CALIFORNIA COASTAL COMMISSION

RE: **Revised Findings for Notice of Impending Development 2-97, Pursuant to the University of California Santa Barbara Certified Long Range Development Plan (LRDP) for Public Hearing and Commission Action at the September 10, 1998 Commission Meeting in Eureka.**

EXHIBIT 2
UCSB NOID 2-97
Campus Features

EXHIBIT 3a
UCSB NOID 2-97
Site Plan

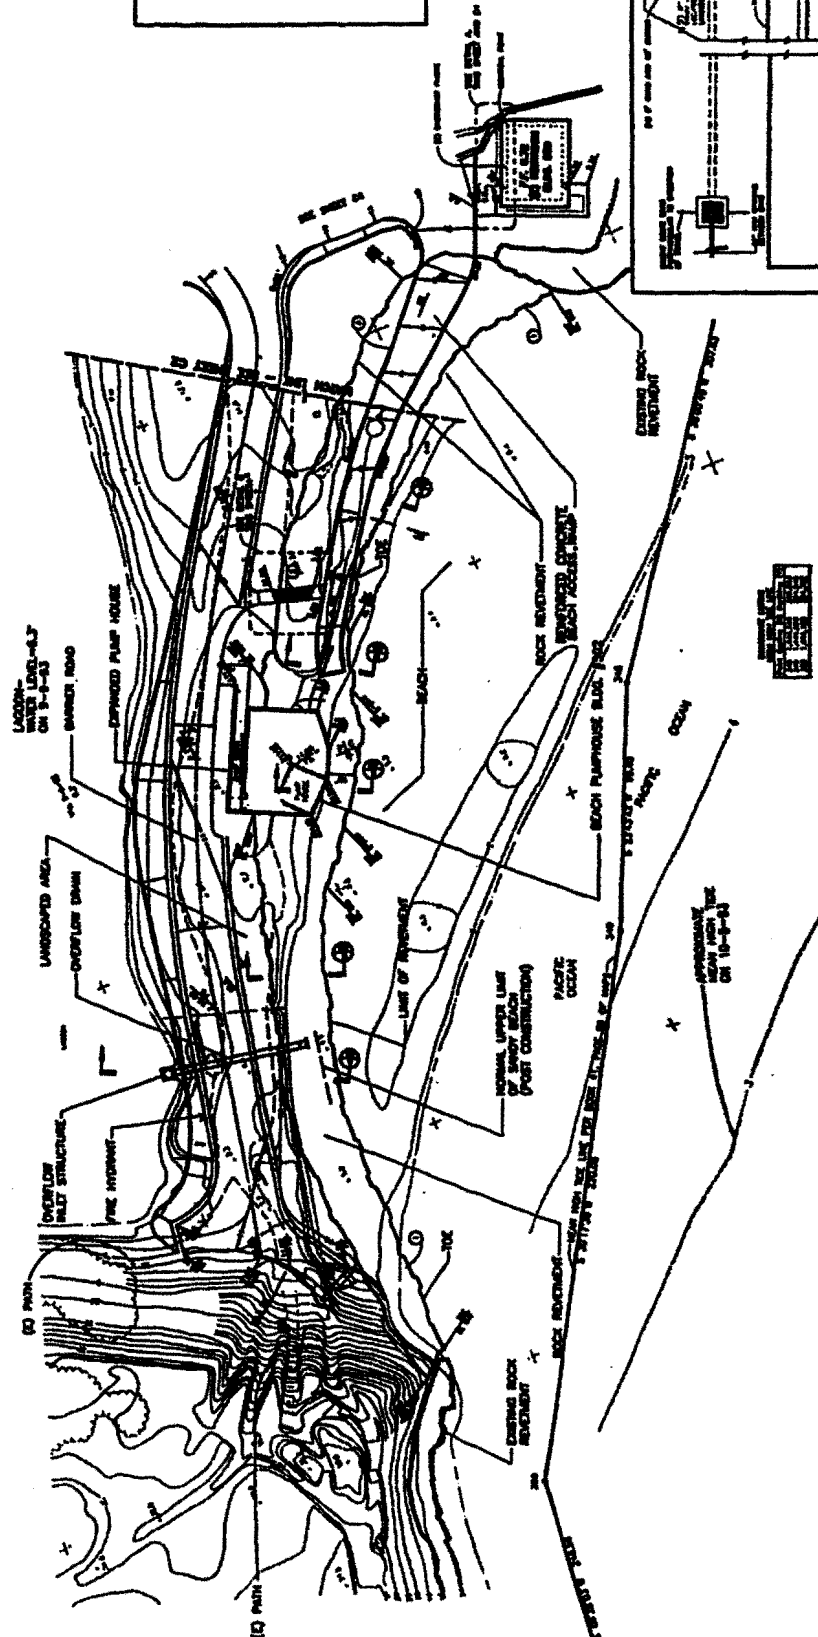
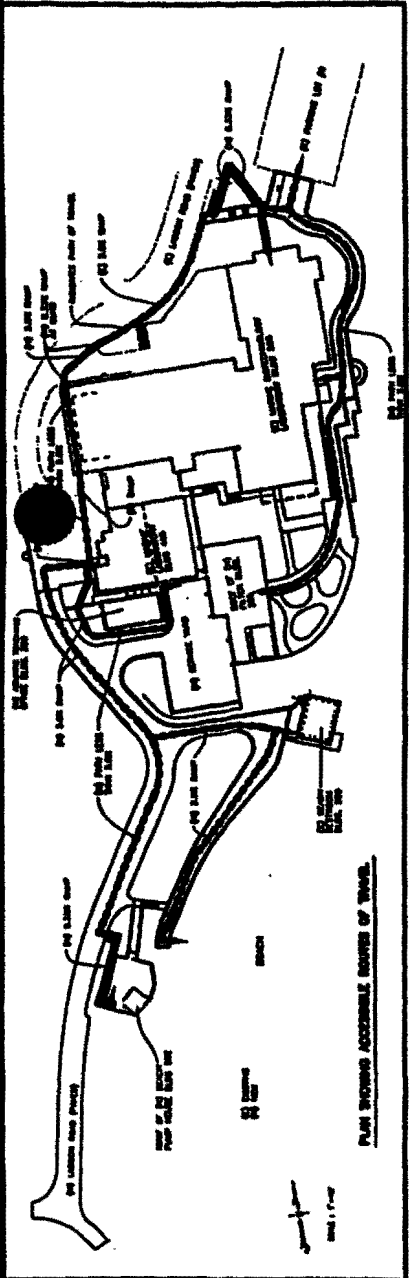
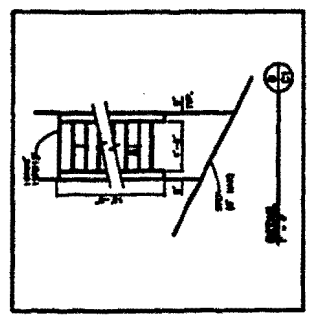
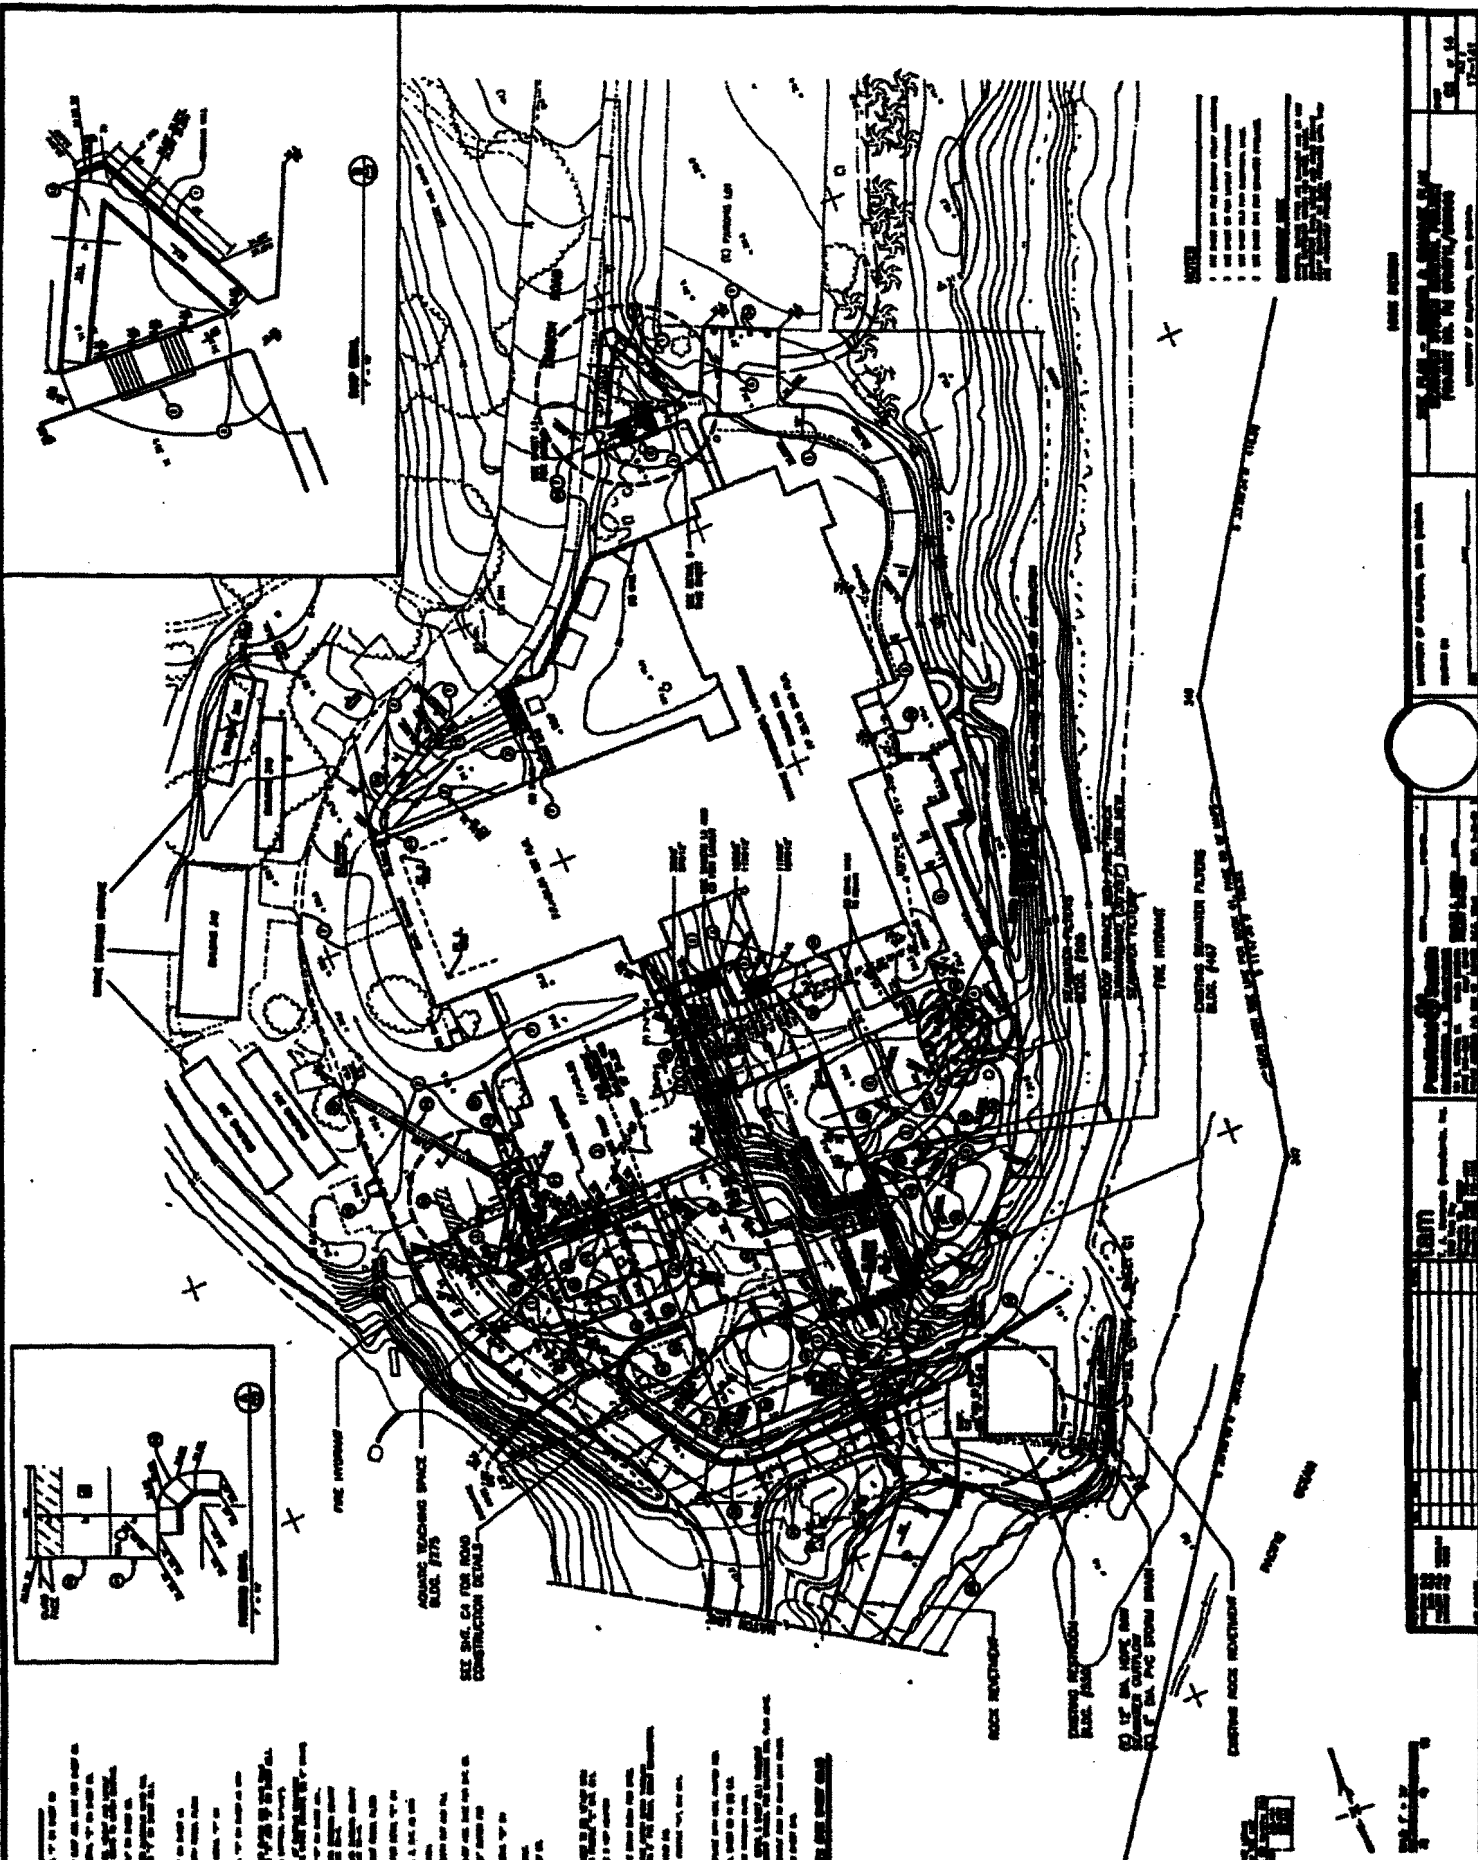
Prior to the commencement of development, the University shall submit, for the review and approval of the Executive Director, revised plans prepared by a qualified civil engineer which eliminate the placement of any fill which would increase the height of the existing lagoon barrier above its present elevation, pavement of the existing road, or the construction of a turnaround.

The proposed grading of the barrier will result in the filling of 0.01 acre of the lagoon wetlands and has been identified in the Environmental Impact Report submitted for this notice as a significant impact. In addition, the pavement of an access road atop the proposed 700 cu. yds. of fill would constitute the construction of a new, or reconfigured, road across the lagoon barrier. Although the amount of fill which will impact the Lagoon wetlands is minimal and the University has proposed 1:1 replacement mitigation in the Environmental Impact Report submitted for this notice, the Commission notes that this activity is not consistent with LRDP policy 30233(a)1. As such, the placement of fill in order to increase

the height of the lagoon barrier and construct the turnaround is not consistent with the applicable habitat protection policies of the LRDP. In addition, the Commission notes that the placement of fill along the barrier is integrally related to the construction of a rock revetment (proposed as part of the related LRDP Amendment 2-97 and Coastal Development Permit 4-97-156) which would also result in significant impacts to the beach ESHA. As such, the placement of fill to increase the height of the lagoon barrier is only necessary in conjunction with the proposed rock revetment. Further, the placement of fill in order to increase the height of the lagoon barrier is not consistent with Part 2, Chapter VI, Section D of the 1990 LRDP as recommended by modification one of LRDP Amendment 2-97 which would prohibit the placement of fill in order to increase the height of the existing lagoon barrier. Therefore, Special Condition Two (2) has been required in order to ensure that the proposed improvements to the lagoon barrier, including the placement of fill to increase the height of the barrier, pavement of the road, or the construction of a turnaround, are deleted from the approved project plans.

The placement of 700 cu. yds. of fill in order to raise the height of the revetment to 11 ft. MSL and to construct the turnaround will create a difference in elevation between the access road and the sandy beach (sand elevation is approximately 5 ft. MSL at the lagoon barrier according to University information) of approximately 6 ft effectively restricting or eliminating public access to the sandy beach. In addition, the pavement of an access road atop the proposed 700 cu. yds. of fill would constitute the construction of a new, or reconfigured, road across the lagoon barrier. As such, the placement of fill in order to increase the height of the lagoon barrier and construct the turnaround is not consistent with the applicable public access policies of the LRDP. In addition, the Commission notes that the placement of fill along the barrier is integrally related to the construction of a rock revetment (proposed as part of the related LRDP Amendment 2-97) which would also result in significant impacts to public access to and along the beach which is located within public tidal lands. The placement of fill to increase the height of the lagoon barrier is only necessary in conjunction with the proposed rock revetment. Further, the placement of fill in order to increase the height of the lagoon barrier is not consistent with Part 2, Chapter VI, Section D of the 1990 LRDP as recommended to be modified by Modifications One (1) and Five (5) of LRDP Amendment 2-97 which would prohibit the placement of fill in order to increase the height of the existing lagoon barrier. Special Condition Two (2) has been required in order to ensure that the proposed improvements to the lagoon barrier, including the placement of fill to increase the height of the barrier, pavement of the road, or the construction of a turnaround, are deleted from the approved project plans.
